From: Gerry Houlder, Seagate Technology <gerry.houlder@seagate.com>
Subj: SAS-2.1 SPL: Add low power transceiver options
Date: Dec. 16, 2008

SAS-2+ Changes (based on SAS-2 rev.14f):

Figure new1 – SAS transition to phy power management

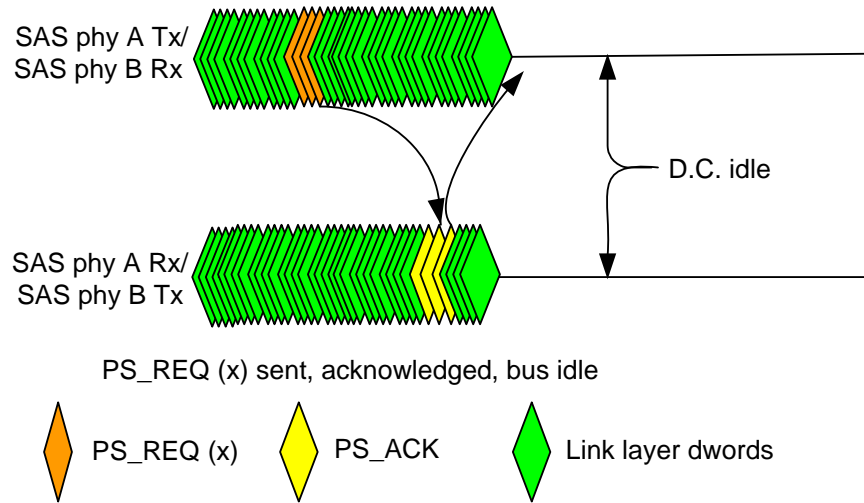
Figure new1 shows the sequence to transition from active to low phy power management condition.

Figure new1 shows a transition from both ends transmitting link layer dwords to D.C. idle. The sequence proceeds as follows:

- 1) phy A transmits PS_REQ (x) primitive to phy B;
- 2) phy B transmits PS_ACK primitive to phy A;
- 3) both phys remember link rate, training settings, SSC setting, and multiplexing setting;
and
- 4) both phys transition to the requested D.C. idle.

Figure new2 – SAS COMWAKE wakeup sequence

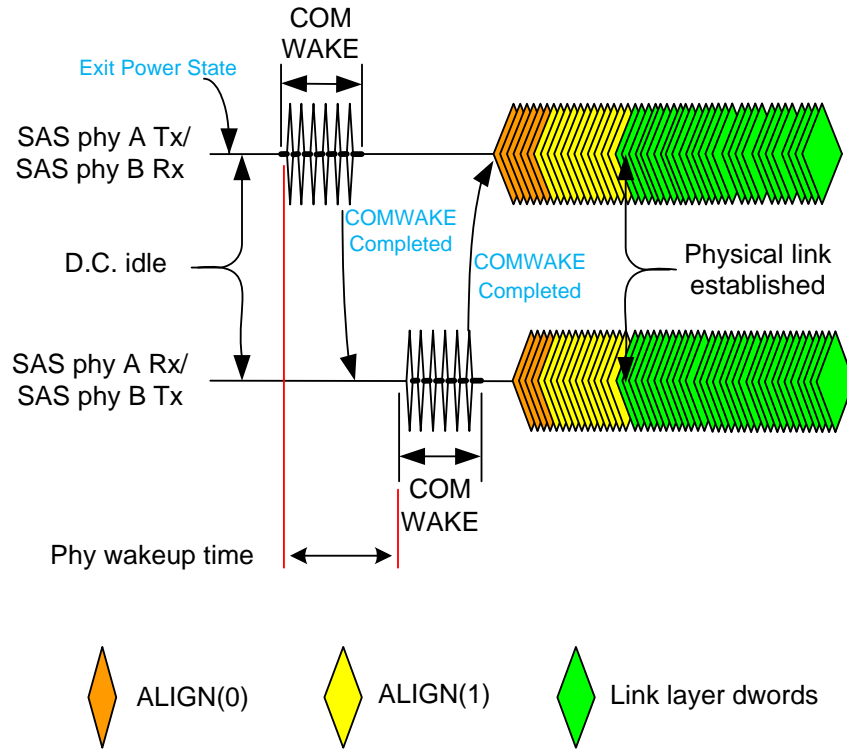
The sequence to recover from either partial or slumber phy power management condition is shown in figure new2.

The COMWAKE recovery sequence is as follows:

- 1) phy A initiates exit power management action by transitioning to active condition;
- 2) phy A transmits COMWAKE;
- 3) phy B detects COMWAKE, initiates exit power management action and transmits COMWAKE back to phy A;
- 4) both phys transmit ALIGN (0) primitives at previously negotiated settings;
- 5) when each phy receiver synchronizes on ALIGN (0)s, that phy transmitter changes to transmitting ALIGN (1)s;
- 6) when each phy receiver synchronizes on ALIGN (1)s, that phy transmitter changes to link layer dwords; and
- 7) if phys are multiplexed, the link layer transmits the multiplexing sequence (see 6.7.4.3) to align the logical links.

The link is now re-established with the same transfer rate and SNW3 settings (e.g., SSC mode and multiplexing mode) that were negotiated before the link was placed in phy power management condition.

Figure new3 – COMWAKE hot-plug examples

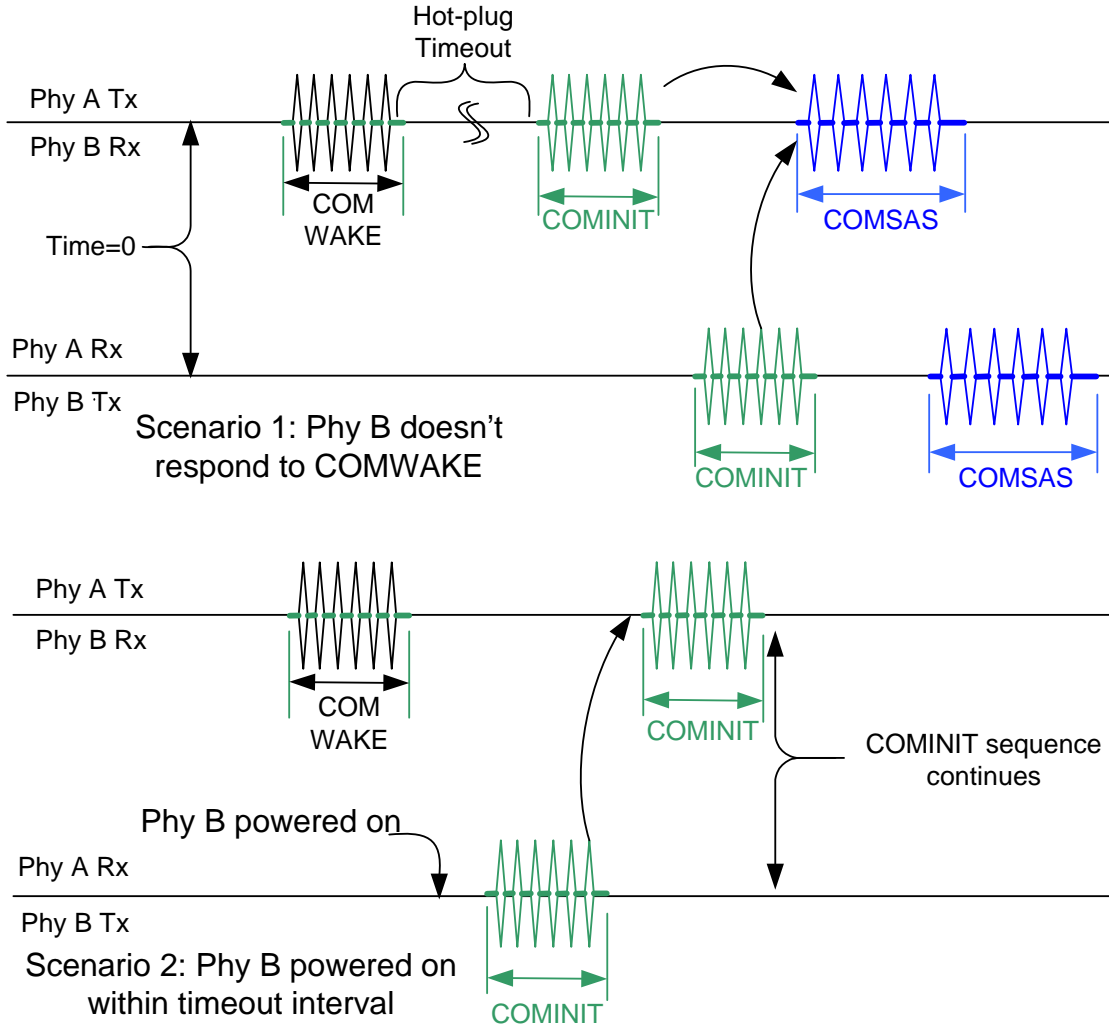
Figure new3 shows examples of hot-plug scenarios that may occur during phy power management recovery.

Scenario 1 depicts:

- 1) [phy A starting a phy power management exit request;](#)
- 2) [phy B target doesn't respond within timeout limit; and](#)
- 3) [phy A recovers by changing to COMINIT sequence.](#)

Scenario 2 depicts:

- 1) [phy A starting a phy power management exit request;](#)
- 2) [phy B is powered on and begins COMINIT sequence within the timeout limit; and](#)
- 3) [phy A proceeds by continuing the COMINIT sequence.](#)
